Central Planning Authority

Minutes of a meeting of the Central Planning Authority held on June 10, 2020 at **10:00a.m.** via e-conference.

CPA/09/20

Figure 1: Site Plan extract overlaid onto DOE's 2013 Habitat Map

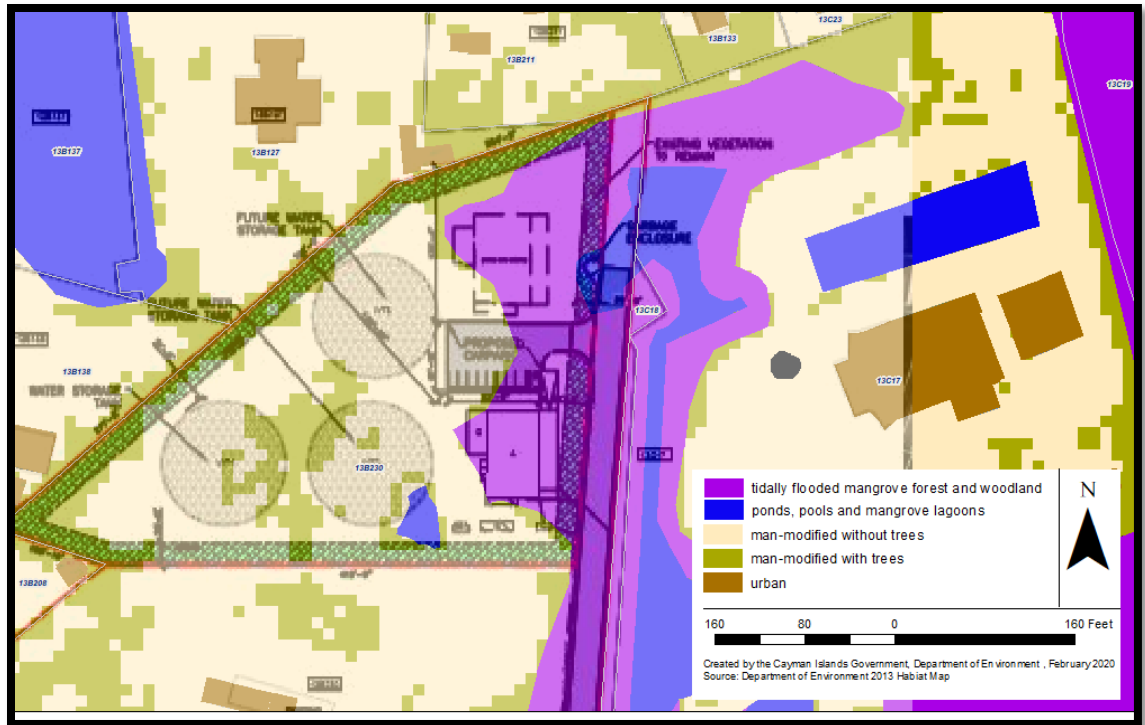
- *The application site is primarily man-modified with a strip of tidally flooded mangroves along the eastern boundary as shown in figure 1*
